Memo

Subject **Response to EPA Comments**
Revised Costs for SWMU 15
Corrective Measures Study for Area C
NIPSCO Bailly Generating Station

FIGURE 1

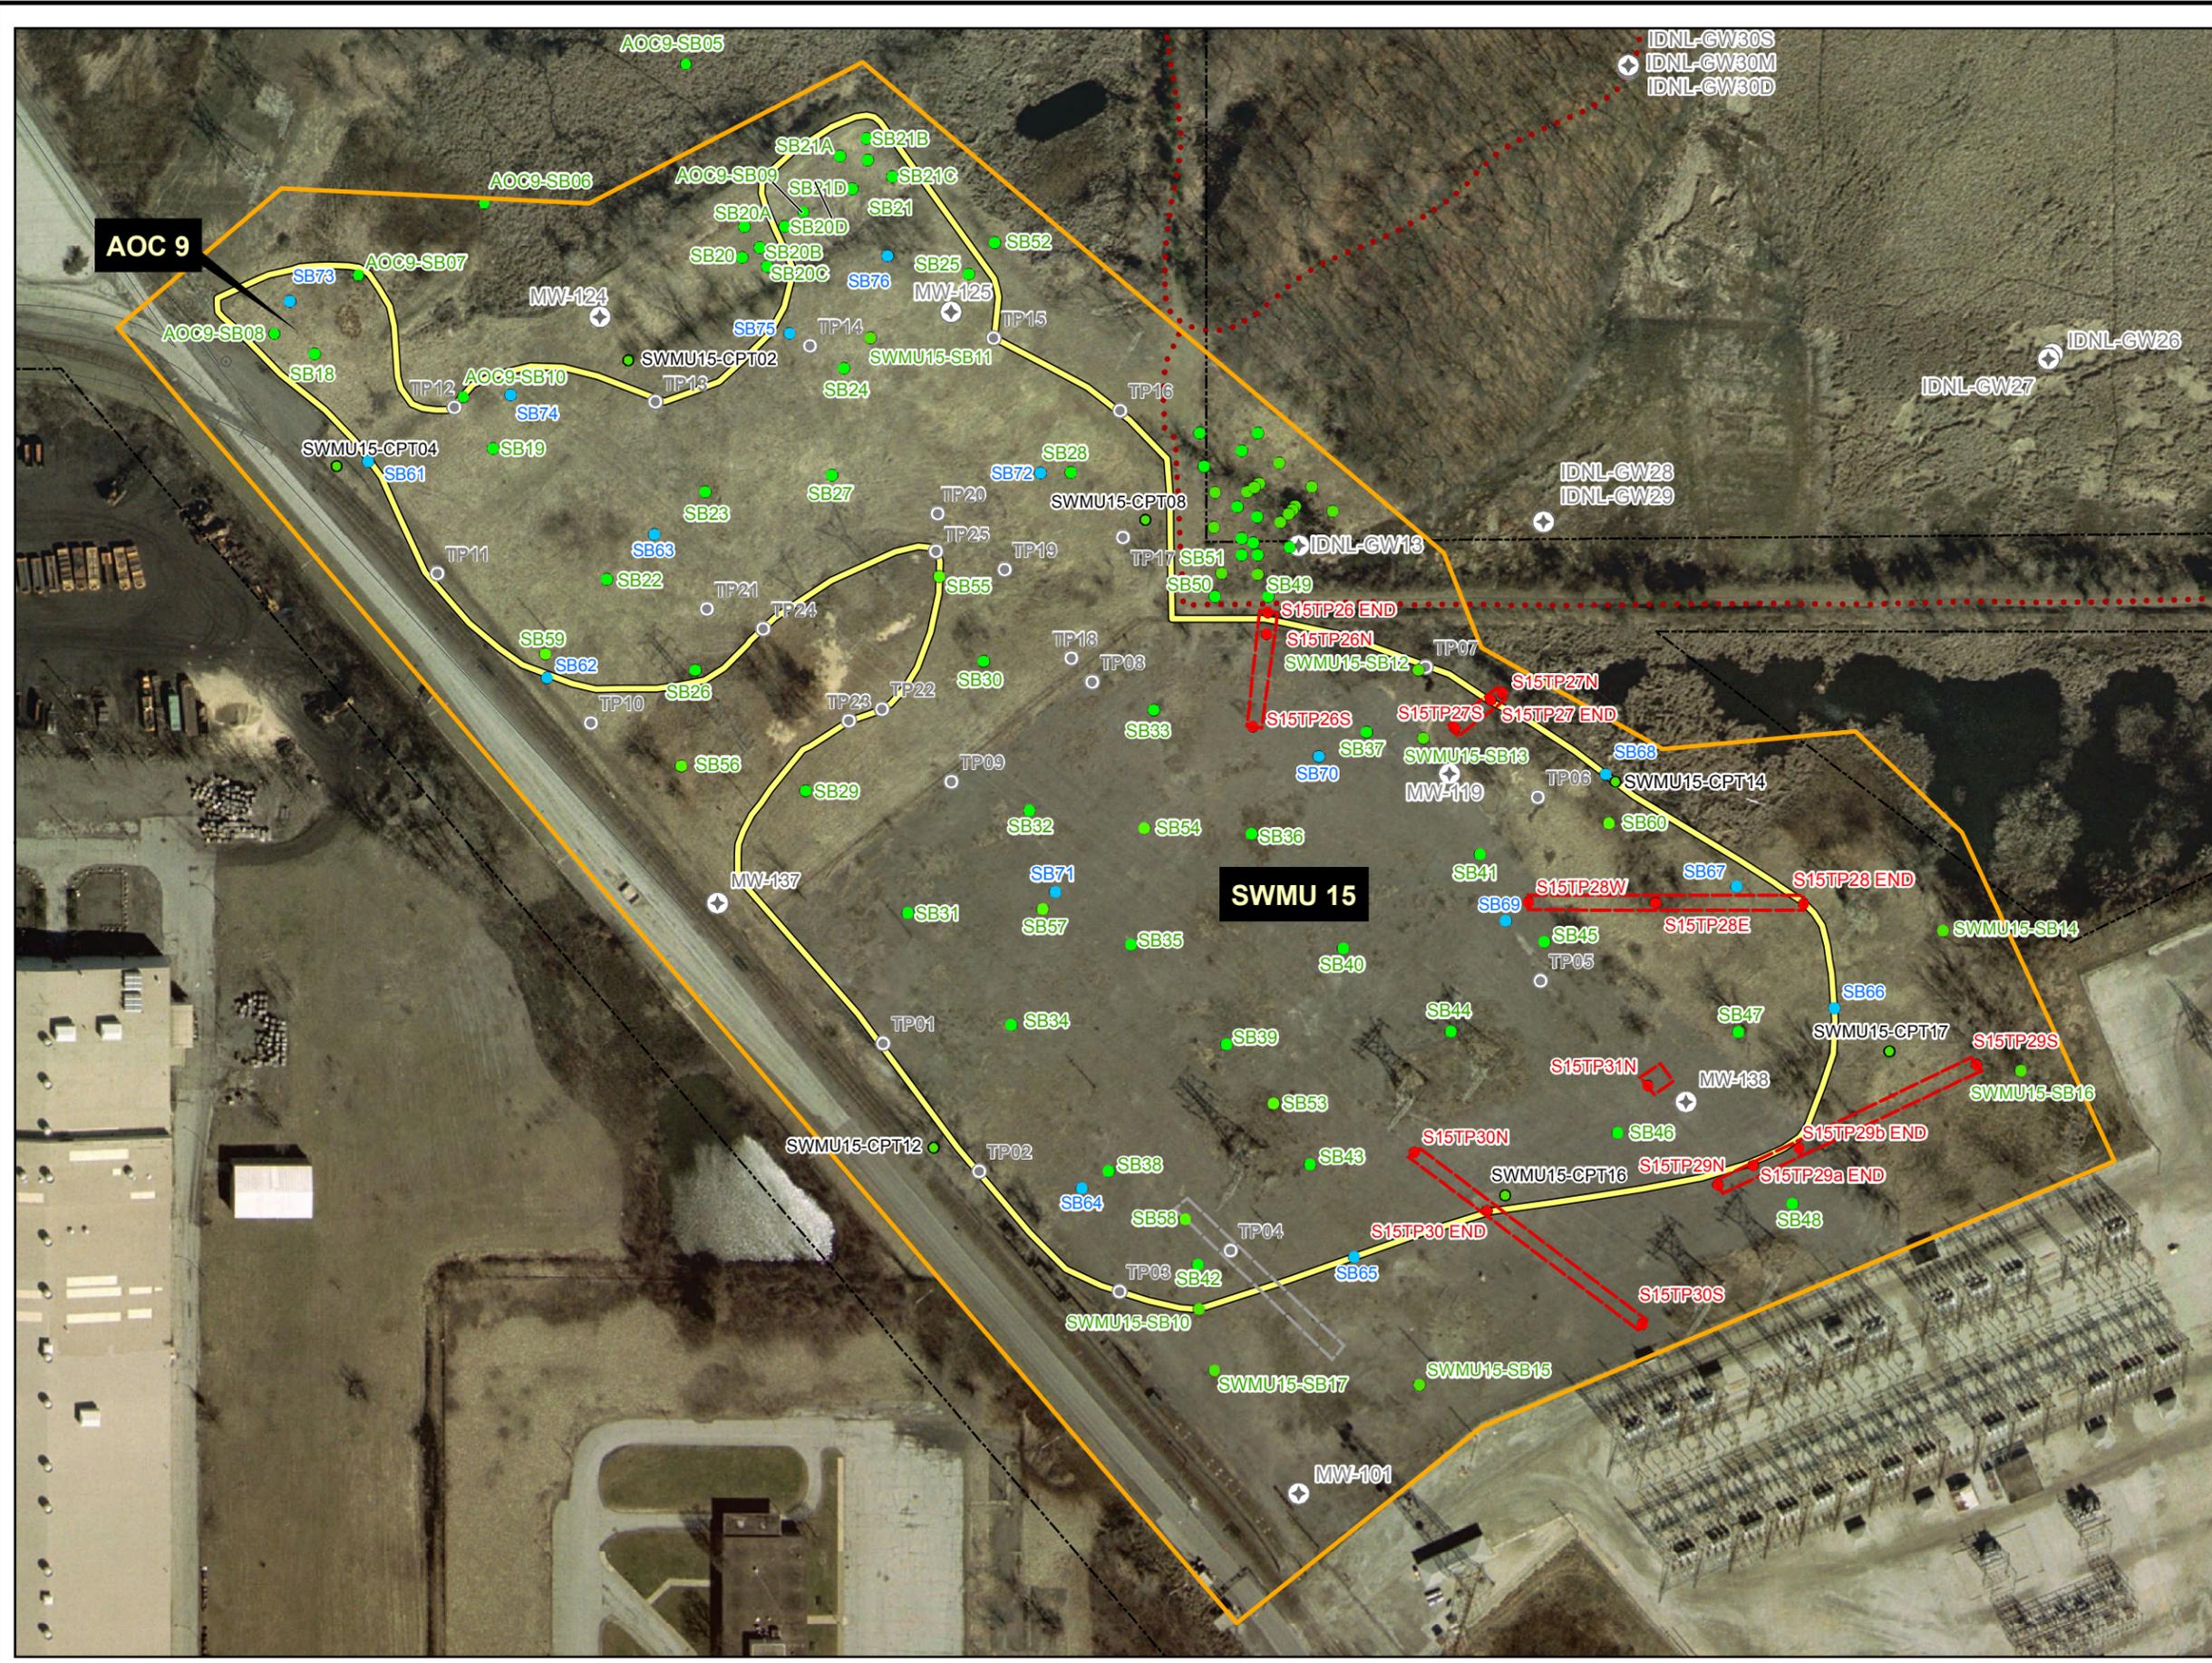
3. The 3 percent Portland cement formulation achieved a boron reduction of 57 percent. However, the Portland cement/blast furnace slag mixture proposed in the June 2, 2017 Revised Costs for SWMU 15 Technical Memorandum; and the 3 percent Portland cement, 6 percent blast furnace slag, and 2 percent Enviroblend® formulation; achieved only 7 and 9 percent reductions in boron concentrations, respectively. It should be noted that prior to reagent mixing, the untreated

CCR SPLP leachate contained 723 µg/L of boron, a concentration below the cleanup criteria of 1,600 µg/L. As the concentration of boron in this composite sample was already below the cleanup criteria, it does not appear that it would be representative of the CCR on site where concentrations of boron in groundwater are in excess of 5,000 µg/L. It is important to determine whether the low initial concentration of boron was a function of compositing or whether the available boron in the composited samples had already been leached out prior to field sample collection. Absent this information, the boron tests may be inconclusive.

NIPSCO Response: As indicated in the Response to Comment #7, NIPSCO intends to conduct another ISS bench-scale study using the LEAF method to potentially improve on boron reduction. Sample material for the bench-scale study was composited from borings SWMU15-SB27, SWMU15-SB28, SWMU15-SB32, and SWMU15-SB45 (see Figure 1) based on visual assessment of the CCR, and the continuity and thickness of the CCR at each location, to ensure that sufficient sample volume would be available for the bench-scale study and that most of the CCR came from below the water table. These requirements necessitated the collection of sample material from borings advanced through deep CCR deposits. The future study will consider groundwater analytical results from the few wells screened within the CCR when designing the sample collection plan. Historically, boron concentrations in groundwater have been elevated at MW-119, where CCR deposits are also deep.

Note that well MW-119 was installed in 2005 and groundwater from that well reflects porewater concentrations that are in equilibrium with the CCR. The pH of groundwater at MW-119 is typically around 9 standard units. Conversely, the aqueous concentrations for the untreated CCR (Table 2 of the Kemron Report) were derived using Method 1312 (SPLP), which uses a pH of 5 standard units. Therefore, it is important to remember that the ISS bench-scale study provides a comparative analysis of the eluent concentrations before and after solidification using a method that differs from field conditions. Amec Foster Wheeler will consider ways to more closely mimic field conditions during the next ISS bench-scale study.
